PG&E Letter DCL-25-003

Re: Pacific Gas and Electric Company's Response to California Public Utility
Commission Independent Peer Review Panel Report No. 16

Pacific Gas and Electric Company's Response to CPUC Independent Peer Review Panel Report No. 16

Figure 1. Tornado Plots Highlighting Hazard Significant Seismic Source Parameters for DCPD for 5 Hz. (from PG&E, 2015, Figure 14-9).

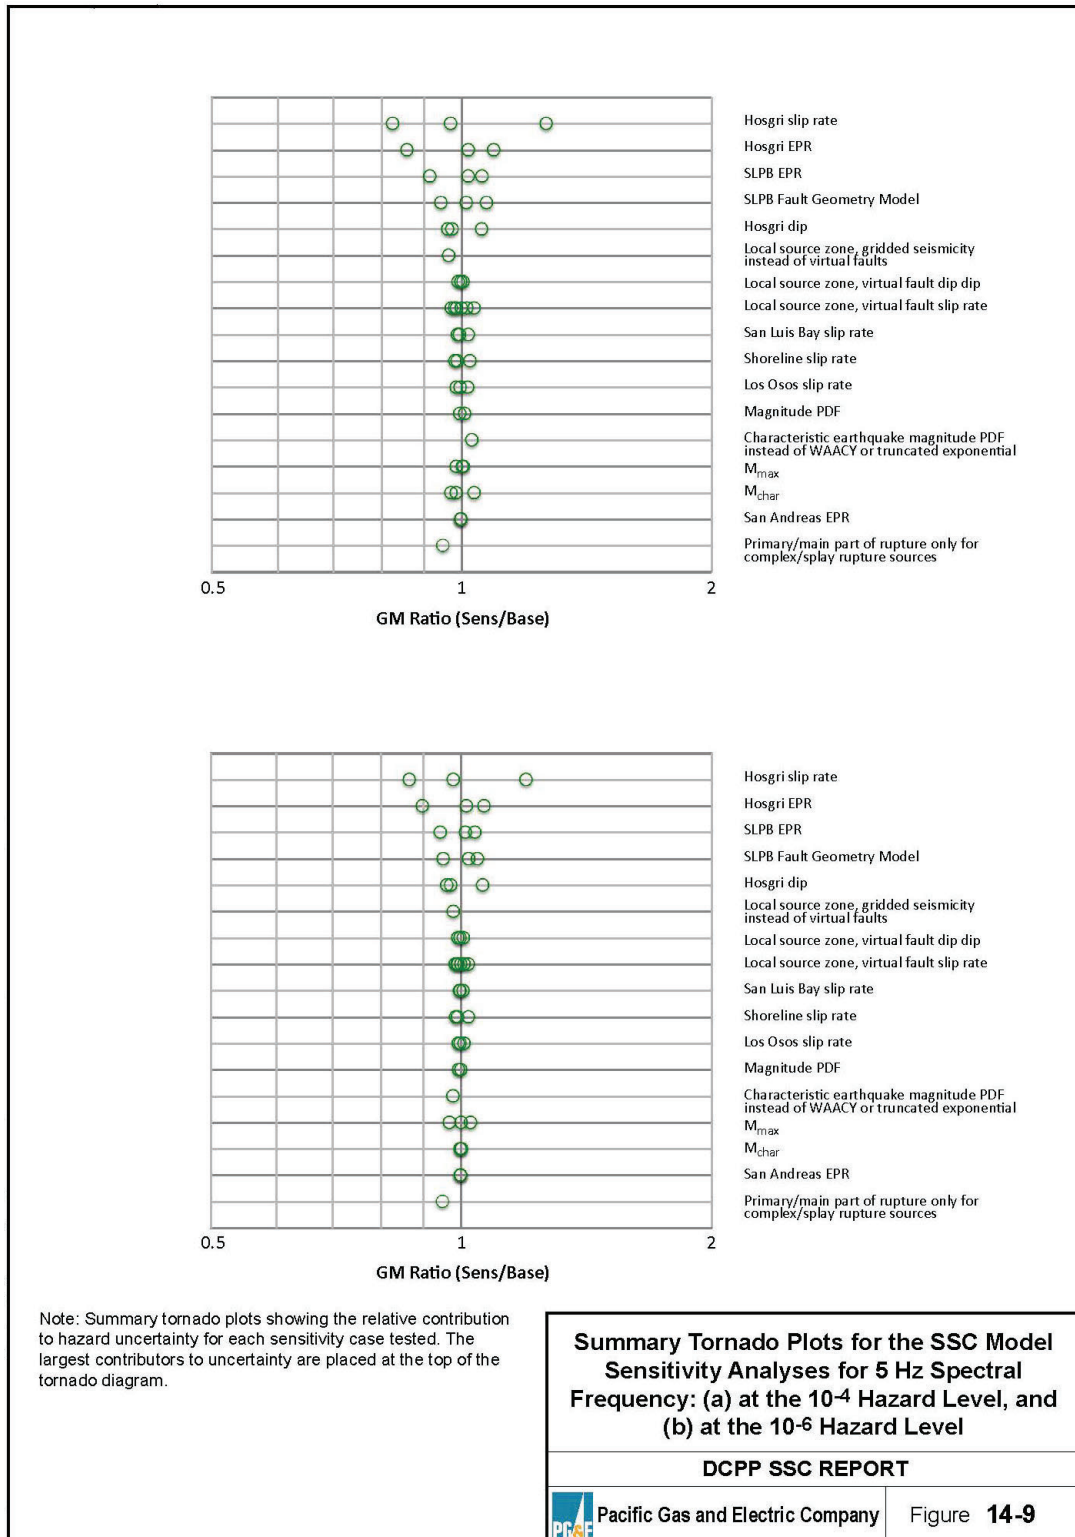
The understanding of the three competing fault geometry models (OV, SV, and NE) remains unchanged from the 2015 report. We still don't know whether the Los Osos fault is a reverse-oblique fault or purely thrust-reverse. We don't know whether the Los Osos fault or San Luis Bay fault is responsible for uplift of the Irish Hills. This unresolved issue of fault geometry highlights the need for improved geologic characterization of the Irish Hills and the bounding faults. Without a single geologic model for the Irish Hills that is clearly supported by hard data, there is greater (perhaps unrecognized) uncertainty regarding the seismic hazard model. Given that the DCPD is located in the Irish Hills, the lack of fundamental understanding of fault geometry

and the mechanism responsible for the uplift appears to limit the potential for meaningful seismic hazard analysis.

The SSHAC process accounts for model uncertainties, such as those in the fault geometry models. Despite uncertainties in the geometry models, coastal terraces provide a strong constraint on uplift rates and are extremely useful for calculating seismic hazard. Sensitivity analysis in the 2015 report indicates that fault geometry is not a hazard significant source of uncertainty (Figure 1).

Figure 2. Hosgri fault slip rate CDFs (PG&E, 2024, Figure 5-41).

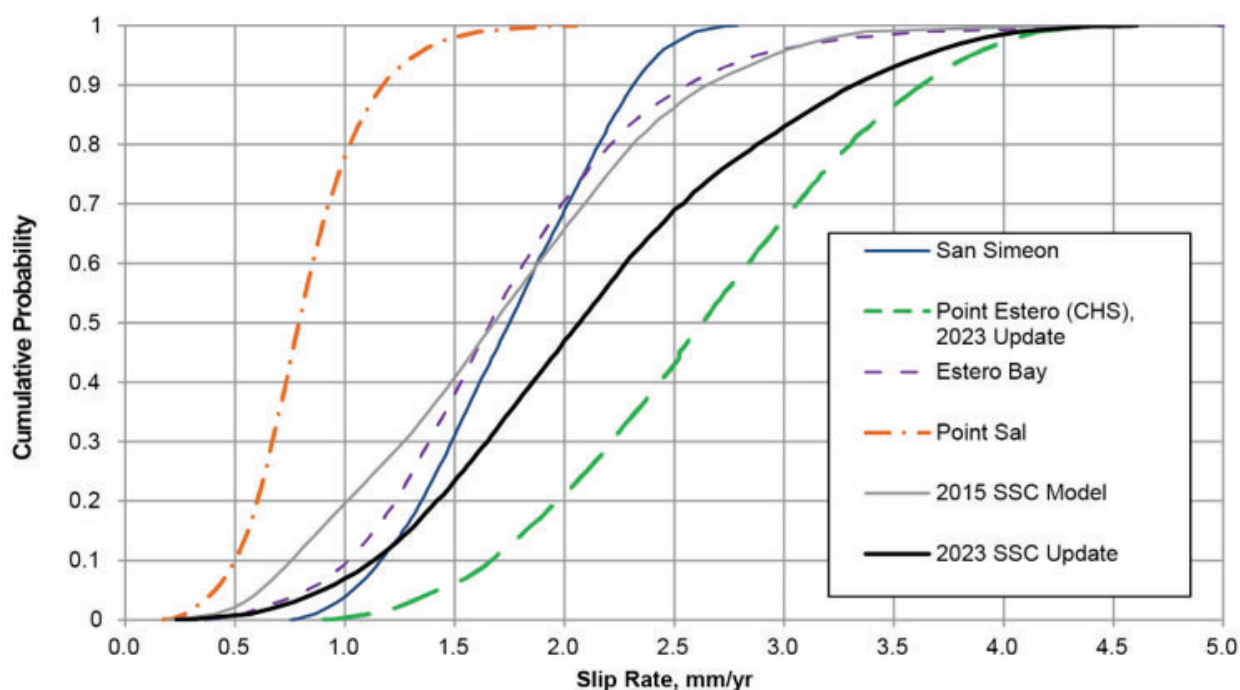
We also question the utility of the slip rate site location criterion, given that all sites are within an anticipated rupture length distance from the DCP. Because we only have confidence in the San Simeon and CHS sites, and the CHS is much closer, we would rank it higher.

In addition, in the data presented, we find no evidence for decrease in the Hosgri fault slip rate from San Simeon to Point Sal in the Holocene. There appears to be very little well-constrained data, such as rates on other structures, that indicates slip rates are changing along strike of the Hosgri fault.

Also, in Figure 2 the full uncertainty range of the Point Sal and Estero Bay sites are provided, and these rates confirm that the CHS slip rate of 2.5 mm/yr is within the range of technically defensible slip rates. Because all the lower slip rates are associated with older features, this may be evidence that the rates were actually slower in the past and hence are not representative of current rates.

An alternative explanation is that these should be considered as minimum rates as the time of initiation on the individual fault strands may be significantly later than the age of the features. In either case, including them may yield an unrealistically low preferred and weighted slip rate.

The model estimates the rate of all Hosgri fault ruptures for the plant. PG&E agrees the decrease in the slip rate of the Hosgri fault from north to south is currently poorly constrained and could be tested further through future LTSP research. However, branching of faults to the east suggests there should be at least a limited decrease

in slip rate southward along strike. This is, in part, why Pt. Sal has some weight (though very low); because the total change is not expected to be significant, the long-term average slip rate of this site MAY be the correct interpretation. Alternatively, the kinematic model for the Hosgri fault may not be complete, and there could be other reasons why the slip rate on the southern part of the Hosgri tapers faster than would be expected given branch faulting.

The IPRP's reasoning does not capture the purpose of the weighting, which is to consider the merits of each site on its own using the criteria described above (age of offset feature, location along the fault, distance from the plant and confidence). The TI Team has concerns that the CHS site interpretation may be misleading. Because the calculated slip rate is very sensitive to the offset amount, the preferred method given the alternatives may not result in the correct displacement amount, and thus the slip rate could be incorrect. If the team believed the CHS rate was 100 percent

accurate and precise, they would not be doing the weighting. Because most other geologic data explored in the Hosgri slip rate assessment suggest more probability mass towards lower slip rates, this probability mass should be factored in.
